## Information to Customers

### Confirmation of mounting positions for SHARP Solar Modules ND-AF, ND-AC as well as NU-AF and NU-AC

#### Clamping on short side

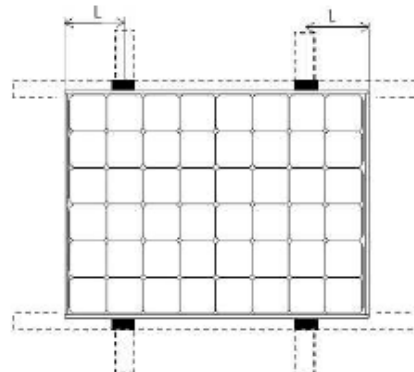
Sharp Electronics GmbH confirms, that the above-mentioned Module series could be mounted with clamps under below described conditions as an extension of the actual Installation Manual. Furthermore, the test load according Mechanical Load Test (MQT16) of EN61215-2 is 2.400Pa. The installation manual attached to the Modules remains valid. The Product- and Power Output Guarantee in the version at the date of purchase by the end user remains valid. Damages caused by mechanical overload are excluded from the Product Guarantee.

S between 0 and  $\frac{1}{4}$  \* Module width from the corner

L between 0 and  $\frac{1}{4}$  \* Module length from the corner
